URBAN DESIGN COMMITTEE

ITEM 2: 25th & Vine Redevelopment

MAIN FLOOR
 L. A. REAL ESTATE LLC
 VINE STREET STUDY
 LINCOLN NEBRASKA

A100

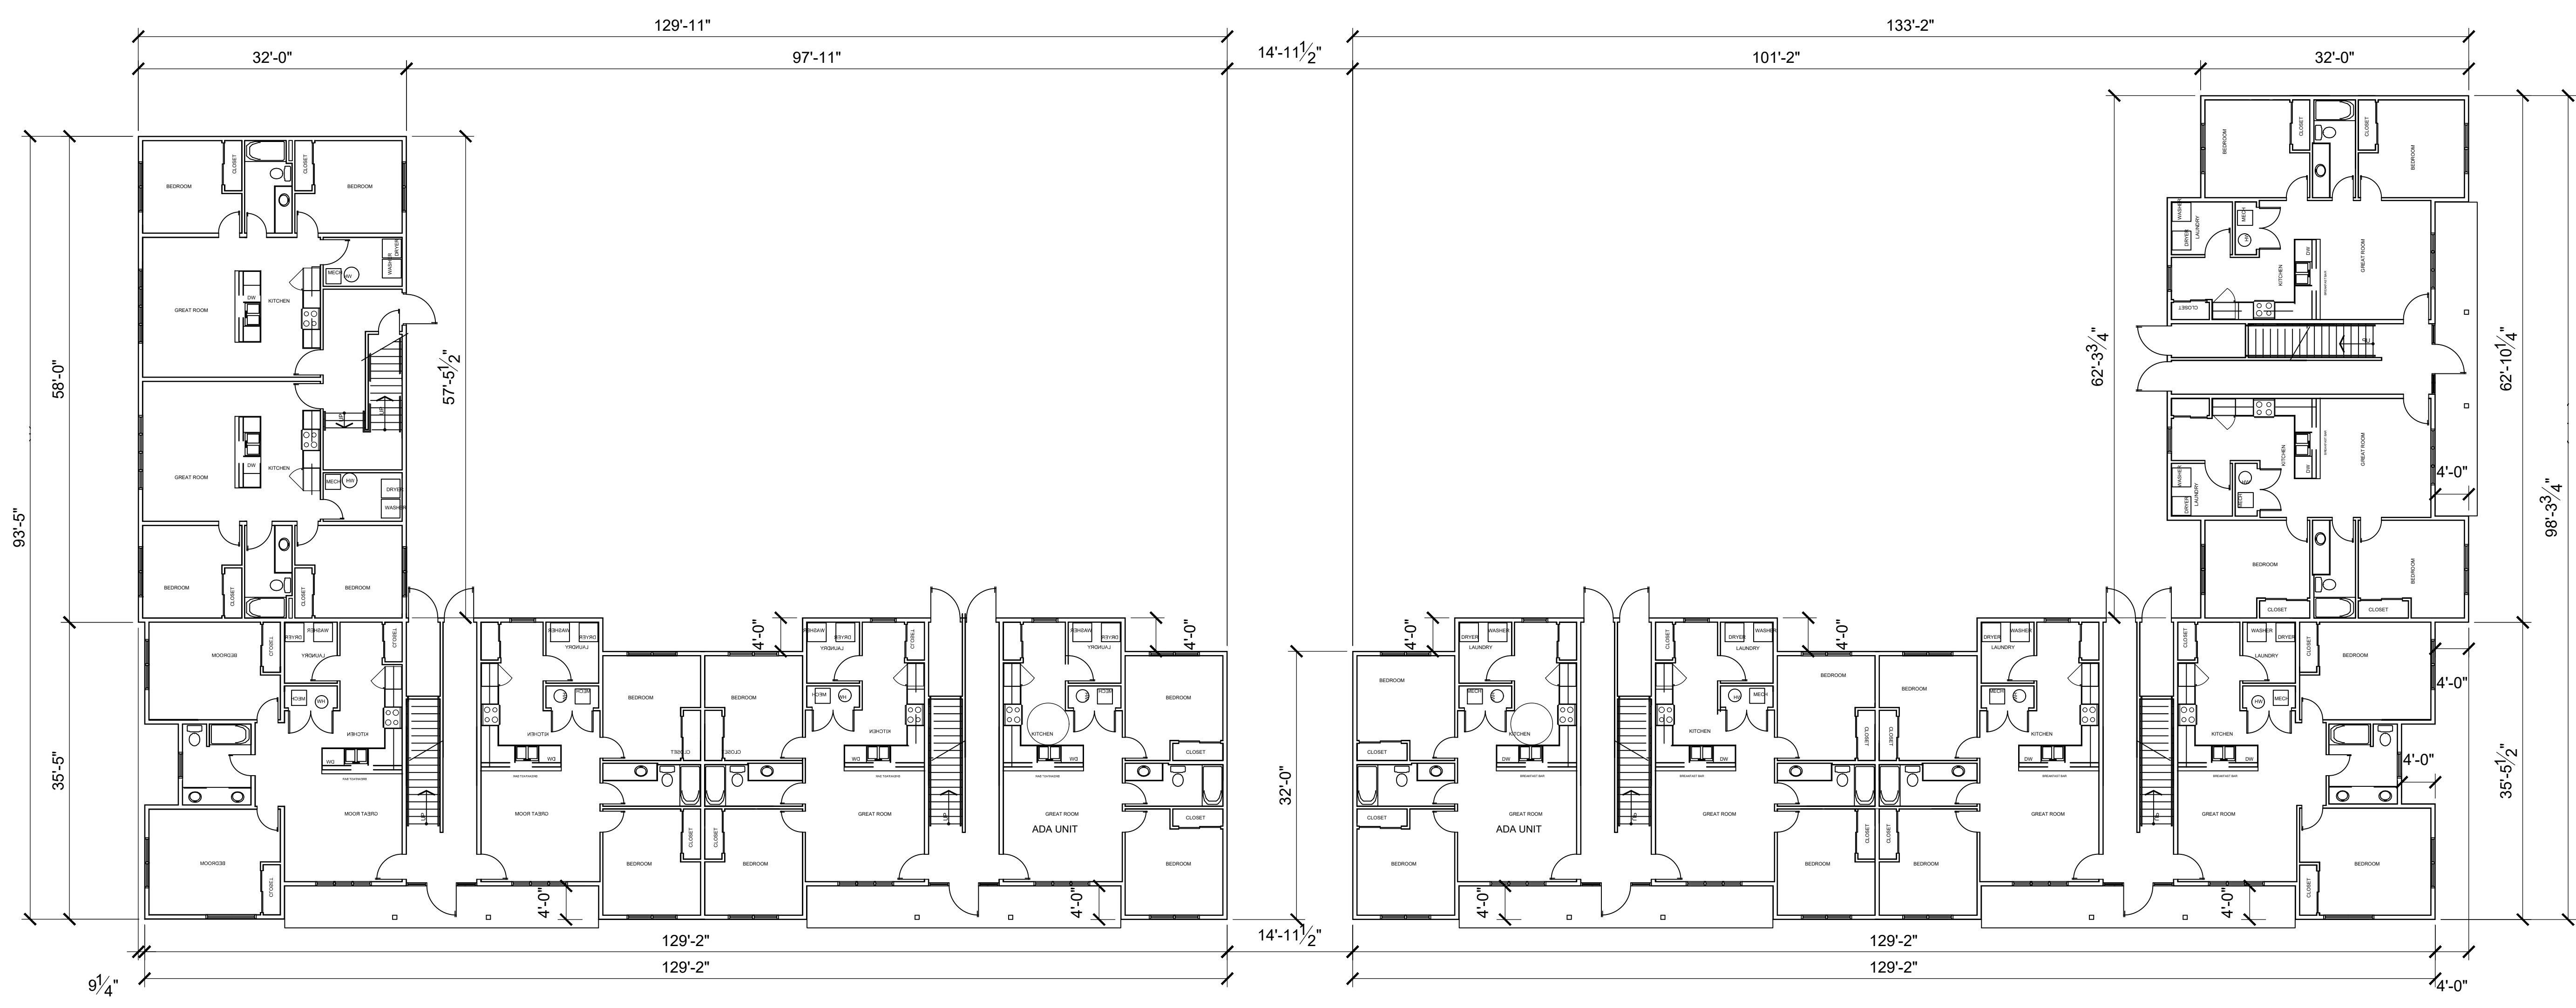
As per last month's discussion, one standard warrants further discussion and interpretation:

The rhythm of similar width houses on similar width lots does much to establish the character of Lincoln's established residential areas. Large new buildings disrupt this character, unless design measures are employed to reduce their apparent scale. New buildings over fifty feet (50') in length on the principal street facade should be designed to maintain the rhythm of the existing adjacent buildings. Designs will be bound to meet this standard which offset the principal street facade and roof at intervals of fifty feet (50') or less. These offsets shall be at least six feet (6') in depth, and the portions of the facade offset shall equal at least 10% of the length of the facade. Alternate designs that maintain the rhythm of the blockface by such means as shifts in materials within the facade, use of multiple porches and/or dormers, and grouping of windows and entrances, may also be approved on a case-by-case basis.

The proposed façade is articulated with roof features and offsets in the façade. The offset distance has increased from last month's submittal. Methods to further articulate the Vine Street façade were asked to be considered. Color was proposed as a way to provide variation. The use of color should be evaluated to determine if it achieves greater articulation.
